TECH BULLETIN 123

Product change: crankcase threaded side screw holes for all 7/8 Frame and 7CP plunger pumps

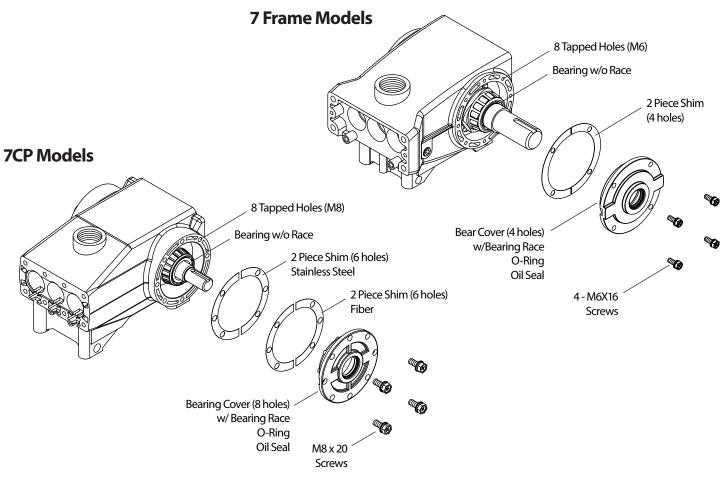
For bell housing and gearbox mounting, Cat Pumps is offering all eight (8) crankcase side screw holes (bearing sides) with tapped threaded holes. The bearing covers and shims will remain the same for the 7 and 8 frame series as well as the 7CP series pumps. This improvement provides additional strength for mounting the bell housings to the crankcase. Previous pump models featured only four (4) tapped holes.
